CALIFORNIA COASTAL COMMISSION

Addendum

Subject: Addendum to **Item W12g, City of San Diego LCP Amendment No. 3-10 (Mission Beach PDO Update)** for the Commission Meeting of March 7, 2012

Diagram 1513-03E
Entry Roof Encroachment

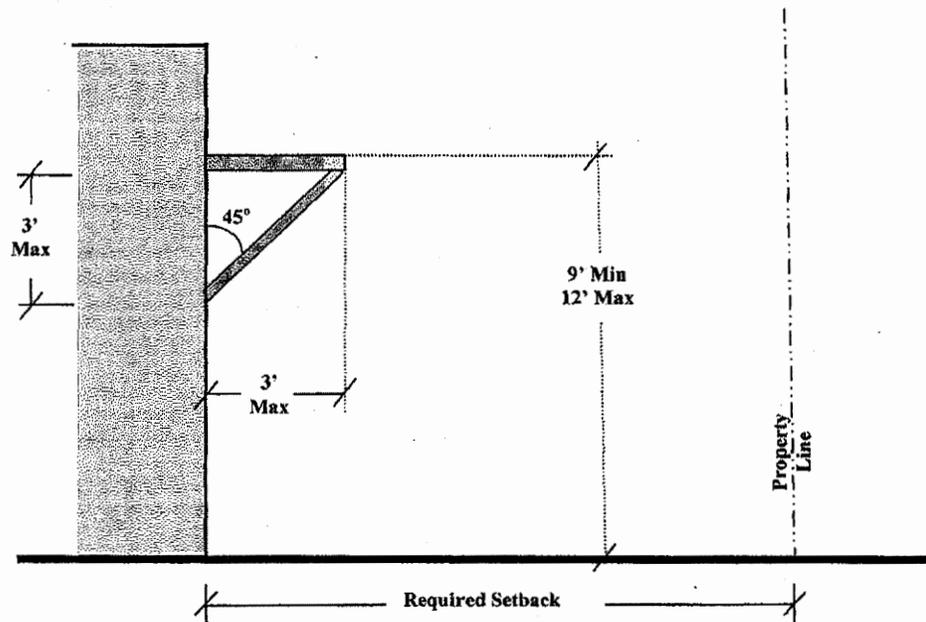
5. Delete **Diagram 1513-03E, Entry Roof Encroachment** illustration from the amended ordinance.

The City has indicated that the goal of including entry roofs as a permitted encroachment into yards along Courts, Walks and Places is to allow residents to construct sturdier, permanent roof covers above entryways. This proposed component of the subject LCP amendment would potentially allow for one 3 foot wide entry roof encroachment in the R-N subdistrict and two within the R-S subdistrict, provided that they are serving separate residential units such as condominiums. However, the proposed modification would allow for the entry roof to stretch the entire length of the entryway plus an additional three feet, extending a substantial distance if constructed above longer sliding glass door entryways. The permanent roof overhangs would also be permitted to encroach up to three feet into the yard area along Courts, Walks and Places, which currently exist as public ocean view corridors. Currently, there are no restrictions in the PDO or the LDC that restrict the use of temporary non-permanent awnings being utilized in the place of roof overhangs. These awnings are typically made of a cloth or fabric material, are less than 3 feet wide and are not as visually obstructive as the proposed permanent entry roof overhangs that would be required to include structural support in the form of diagonal supports attached to the structure.

The Mission Beach Precise Plan includes provisions and objectives requiring that public views to and along the shoreline must be protected through the use of adequate setbacks along Courts, Walks, and Places as well as through provisions restricting encroachments into identified public view corridors within the community. As the lot size and associated required setback areas are already comparatively small and restricted in the community of Mission Beach, any allowable encroachment into the Courts, Places and Walks that function as critical view corridors could result in significant adverse impacts to the visual quality of the community and the availability of public ocean and bay views. Although seemingly minor on a case-by-case basis, the proliferation of entry roofs, along with other appurtenances added over time, could result in cumulative impacts and deterioration of public views. The proposed changes regarding entry roof encroachments would extend beyond the historic allowable building envelope established with the initial

certification of the Mission Beach PDO and would not be consistent with the policies of the Mission Beach Precise Plan, which emphasize that the yard areas abutting Courts, Walks, and Places observe the required setbacks with no significant encroachments that extend above 3 feet. As such, the proposed modification to the PDO, allowing for the three foot encroachment of entry roofs, cannot be found adequate to implement the certified LUP.

of temporary non-permanent awnings being utilized in the place of roof overhangs. These awnings are typically made of a cloth or fabric material, are less than 3 feet wide, and provide adequate protection from the elements. However, the proposed permanent roof overhangs would be significantly more visually obstructive and would be required to include structural support in the form of diagonal supports attached to the structure. As the proposed amendment would allow for a permanent encroachment into the yards along Courts, Walks, and Places that could significantly impede public views to the Ocean, the proposed language and associated table section permitting entry roof encroachments must be removed in their entirety.
